APPLICATION NO.	FILING DATE	FIRST NAMED INVENTOR	ATTORNEY DOCKET NO.	CONFIRMATION NO.
09/806,304	03/29/2001	Alain Brochez	BROC3001/JEK	6723

Office Action Summary	Application No. 09/806,304	Applicant(s) BROCHEZ, ALAIN	
	Examiner ERNESTO GARCIA	Art Unit 3679

DETAILED ACTION

Ekstein, 3,797,194

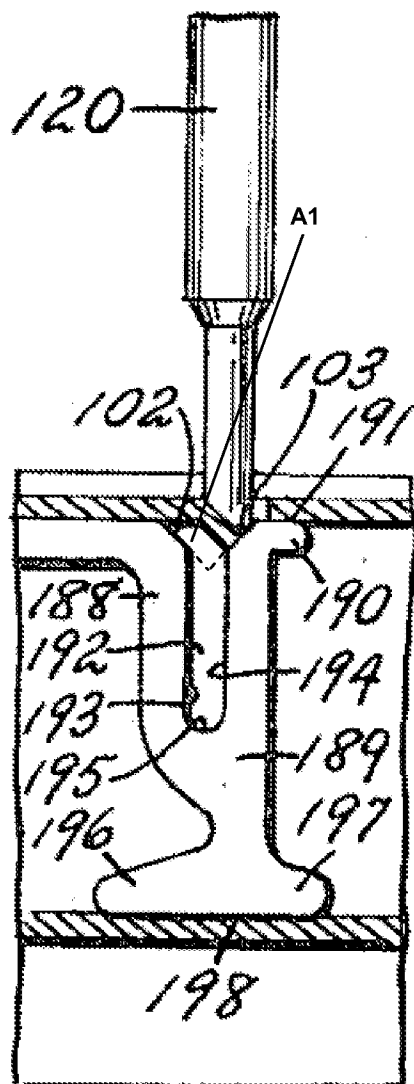
further includes locking means **108, 110** for mutual interlocking the corner piece **16** to the side members **12, 14**. The locking means **108, 110** comprise lips **108, 110** defined by a pressed-in material part of the outer wall **18, 48**. The lips **108, 110** cooperate with notches **A1** (see marked-up attachment) defined on the corner piece **16**. Each of the insert parts **74, 76** includes at least one of the notches **A1** comprising a triangular shape defined by a first side **A2** against which the lip **108, 110** is positioned and a second side **A3**. The locking means **108, 110** generates pre-stress as pressure on both side members **12, 14** and tension in the corner piece **16**. The locking means **108, 110** comprises material parts **108, 110** upset by compressing material of the side members **12, 14**. The upset of the material parts **108, 110** has a useful working force on a mitre. A compression force is created in the side members ends by pushing off both side members **12, 14** on the locking means **108, 110**. The corner piece **16** comprises inclined parts **96, 97** defining a pressure zone between the locking means **108, 110** and a place on the inner wall **36, 66** which is situated deeper in the attachment channels **62, 64** so that pressure is between the place and the locking means **108, 110**. The insert parts **74, 76** comprise resilient members **77** connected to one another at an angle (90 degrees). The inclined parts **96, 97** are respectively connected to the free ends of the resilient members **77**. A free space or clearance (between feature 78 and 100) free of massive material is provided on an outside corner of the corner piece **16**. The free space or clearance extends from the locking means **108, 110** to at least the connecting end of the insert parts **74, 76**. The inclined parts **96, 97** create a tensile force in the resilient members **77** since pressure in the inclined parts **96, 97** results in a tension in

However, Ekstein, fails to disclose the triangular shape of the notch **A1** defined by a first side **A2** against which the lip **108, 110** is positioned being longer than a second side **A3** over which a free end of the lip **108, 110** is pressed in. Instead, the triangular shape of the notch appears to be symmetrical thus creating an isosceles triangle versus a right angle triangle thus giving the required sides as claimed.
